Technical BULLETIN

RECALL This modification has top priority. This bulletin must be performed immediately to ensure customer safety.

All XVS11A, XVS11AT, XVS11, XVS65A, XVS65AT, XVS65, and XV250 FACTORY MODIFICATION CAMPAIGN

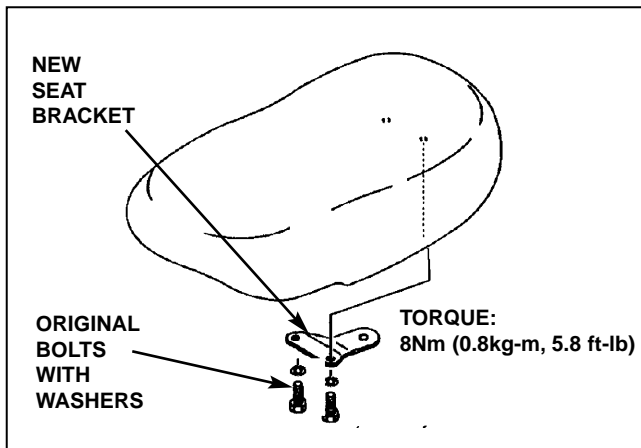
3. Install the new seat bracket from the kit using the original bolts and washers. The new bracket has a larger hole for the grommet.

XVS11A (V STAR 1100 CLASSIC), XVS11AT (V STAR 1100 SILVERADO), XVS65A (V STAR CLASSIC), and XVS65AT (V STAR SILVERADO)

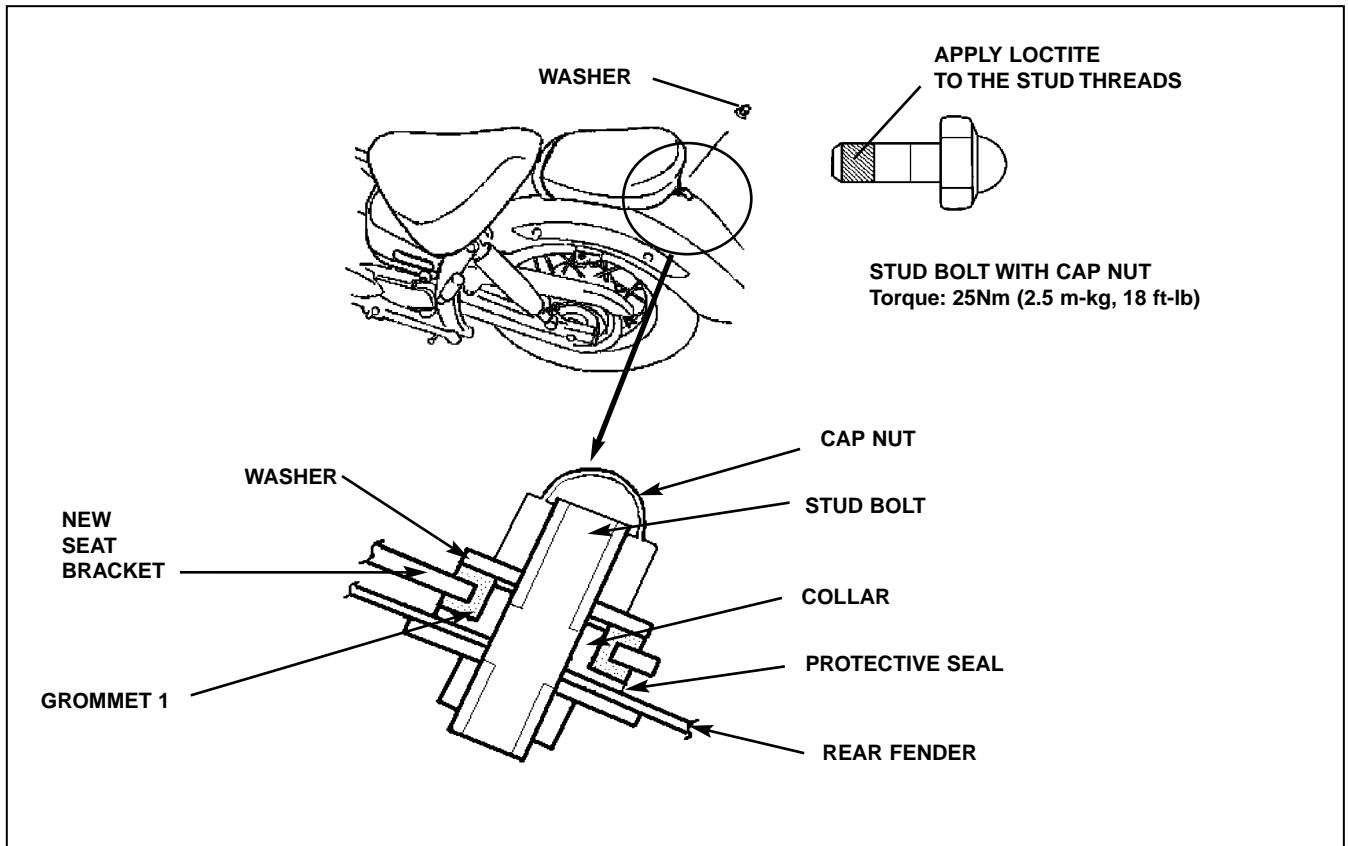
4. Place the passenger seat on the rear fender, making sure the collar is in place in the grommet. Place the new washer from the kit over the grommet. Apply Loctite® 648 or 271 to the shorter threads of the stud bolt (the end opposite the cap nut). Install and tighten the stud bolt with the cap nut.

NOTE: The Loctite® is used to permanently mount the stud to the frame nut.

XVS11 (V STAR 1100 CUSTOM)

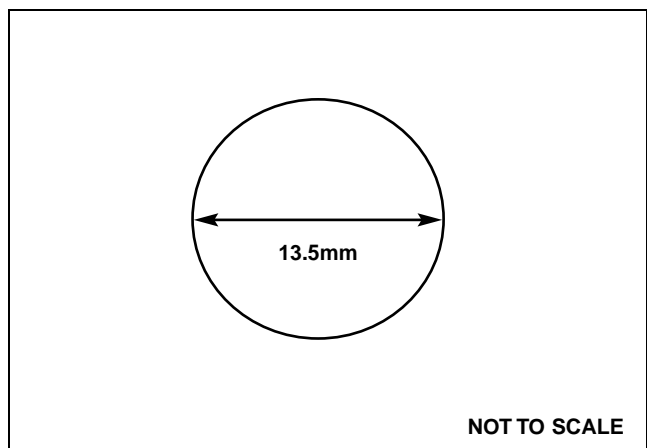
3. Lift the rear fender just enough to access the stud hole. Using a step drill or another appropriate tool, carefully enlarge hole on the rear fender for the passenger seat stud bolt to 13.5mm. Smooth the edges of the hole.

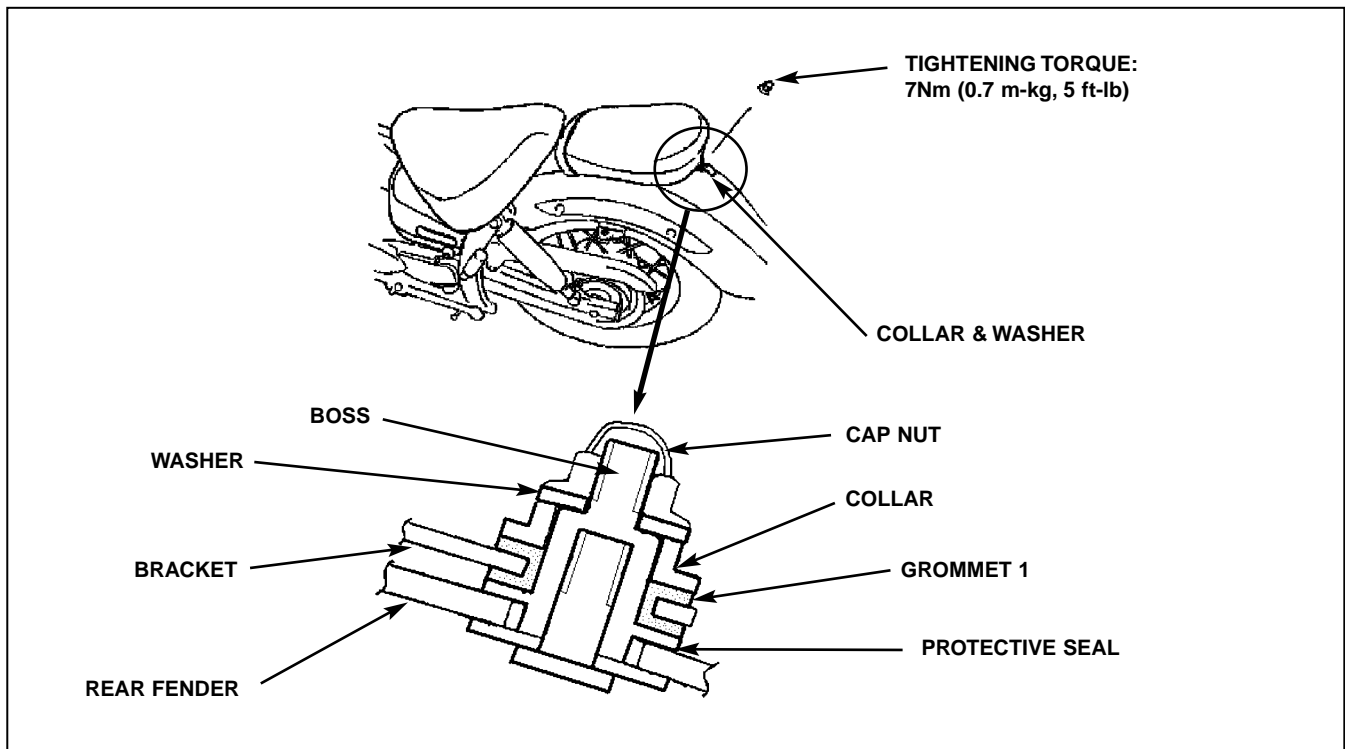
7. Apply Loctite® 648 or 271 (red type) to the mounting stud for the passenger seat. Install the new boss from the kit on the original stud. Tighten the boss to specification.

8. Place the passenger seat on the rear fender.
Place the collar and washer on the grommet
and tighten the cap nut to specification.

NOTE: The Loctite® is used to permanently mount the boss to the stud.

XVS65 (V STAR CUSTOM)

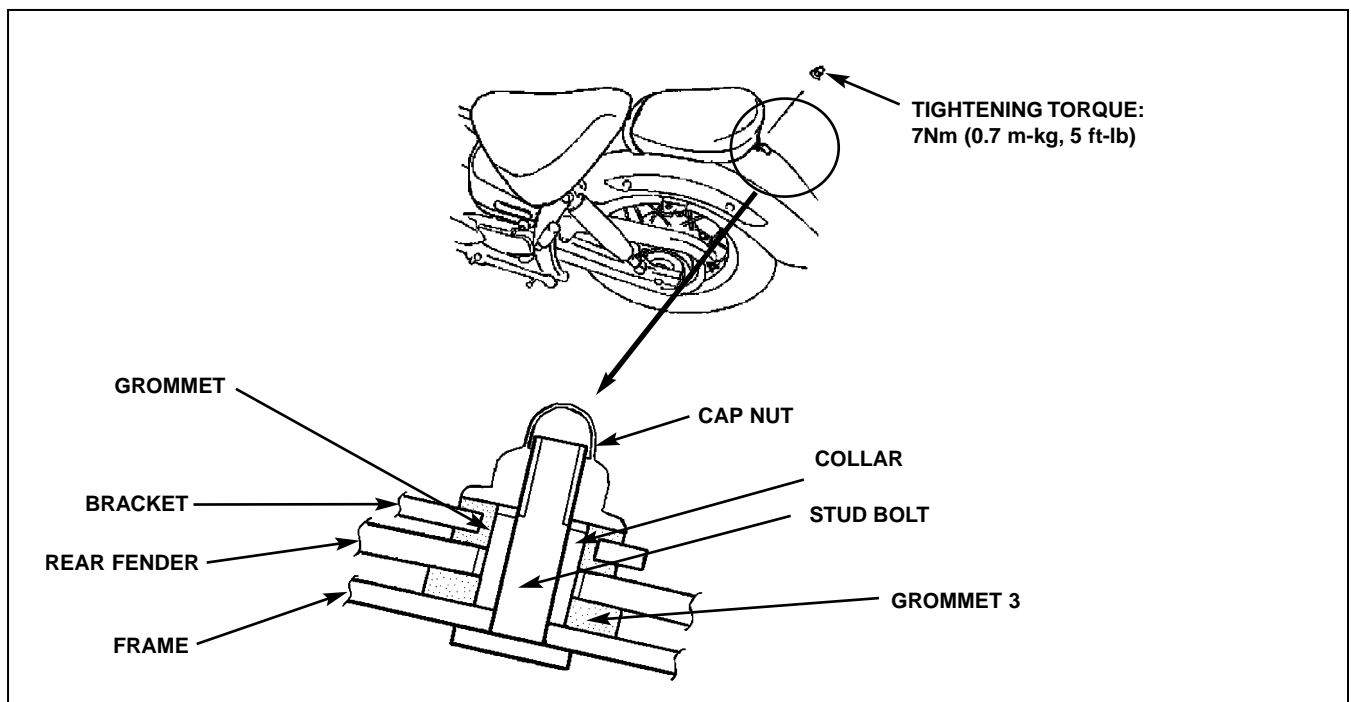
6. Place the new collar from the kit over the stud bolt. Place the seat on the rear fender. Tighten the new nut cap from the kit to specification.

XV250

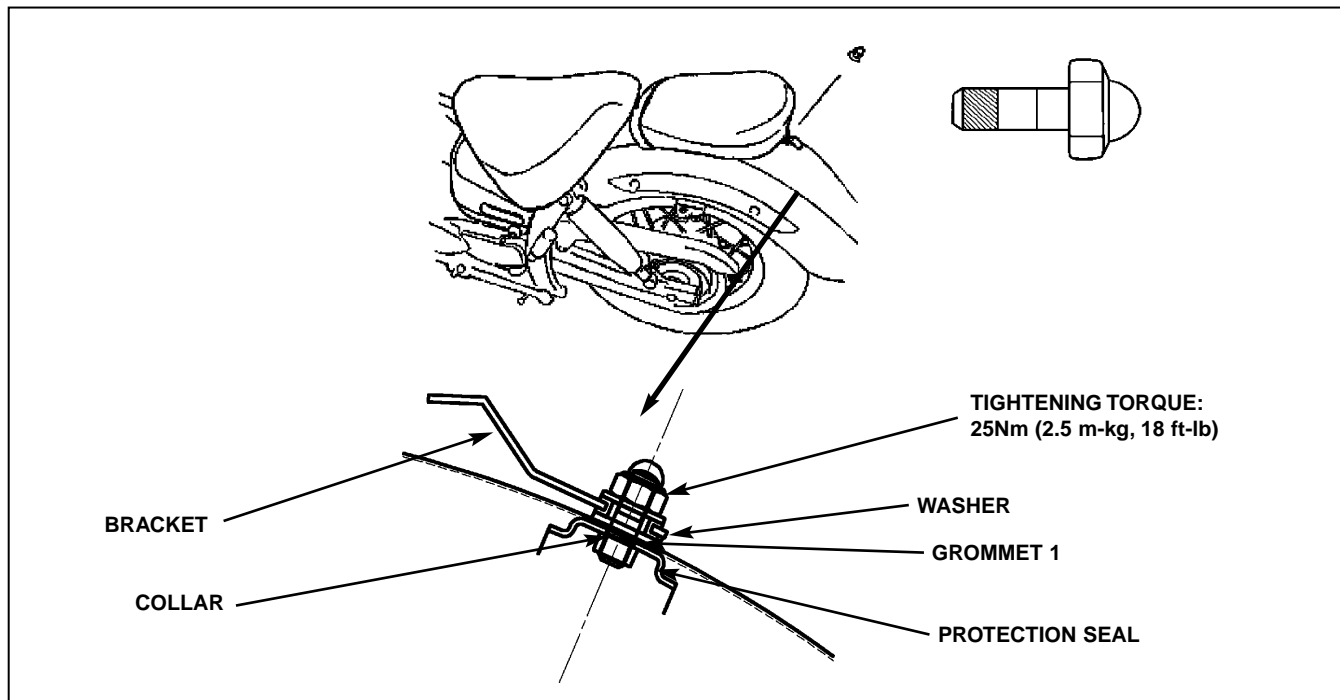
4. Place the passenger seat on the rear fender, making sure the collar is in place in the grommet. Place the new washer from the kit over the grommet. Apply Loctite® 648 or 271 to the shorter threads of the stud bolt (the end opposite the cap nut). Install the stud bolt with the cap nut and tighten to specification.

NOTE: The Loctite® is used to permanently mount the stud to the frame.
